Providence City Plan Commission

AGENDA ITEM 2 ■ 27 E RIVER STREET

**CASE NO./
PROJECT TYPE:** 24-041MI—27 E River Street
Minor Land Development
December 2025 revised

Proposed site plan

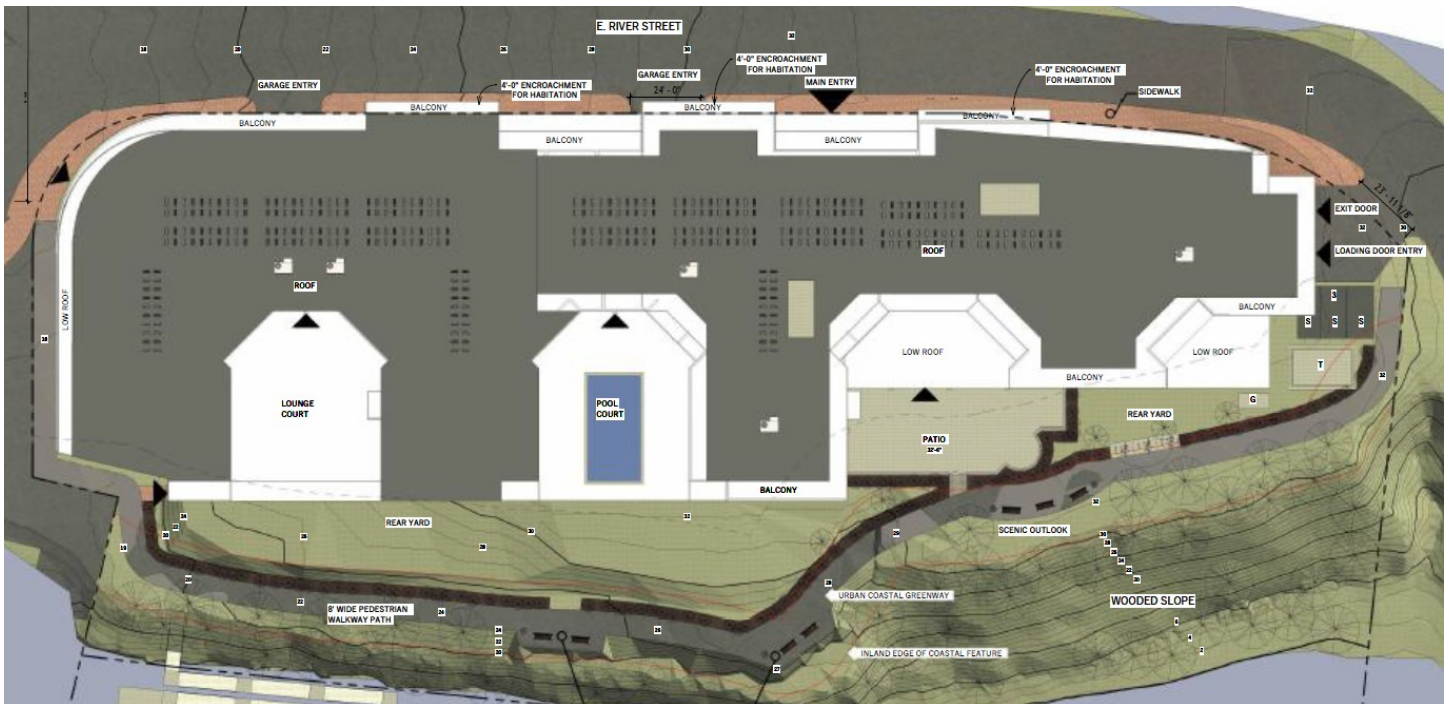
The building will front on River Street and address the ascending grade from south to north. Vehicles can access the internal parking area from two entrances that will provide ingress to the first and second floors of the parking area. A separate pedestrian entrance to the lobby will be provided at a higher grade at the northern portion of the building.

The building will be set to the lot line with the facade curved congruent to the lot. The first three stories will be treated with brick veneer and consist of projecting columns with recesses. The main entrance will be composed of glass. The upper stories will employ metal paneling, glass and cantilevered balconies. The plan indicates that three, four foot encroachment permits will be requested for balconies to project over the public right of way. The ninth story will partially occupy the roof and be set back from the facade. Renderings show alternating projecting and recessed sections providing dimensional variety on the façade. Each façade will exceed 25% of required transparency. The incorporation of varied architectural features, incorporation of adequate transparency and use of permitted materials is in conformance with section 1202.K of the ordinance. A landscaped public walking path and access to a kayak launch will be located in the rear of the lot, separating the development from the river.

Ingress and egress to the internal parking area will be provided from three entrances on E River Street. The first parking level will be in the southeast portion of the lot, the second in the east and the third at the northern portion of the building, providing access to a parking area with a loading space which is required as over 40,000 SF of residential development will be provided. The applicant has requested a 50% parking adjustment to provide 281 spaces for 355 units. A total of 178 spaces will be required when accounting for the adjustment. Of those spaces, 17 will be compact which is within the 10% allowed for developments. In addition, 98 compact spaces over the required amount, ranging in size from greater or equal to 7'9" wide and 15' in length will be included. These spaces will be larger than the compact space size of 7.5' x 15' but smaller than the 8.5' x 18' standard spaces. The parking ratio is approximately .79, which is close to the one to one parking ratio that the CPC required the applicant to build towards. Ninety bicycle spaces will be provided to meet the bike parking requirement.
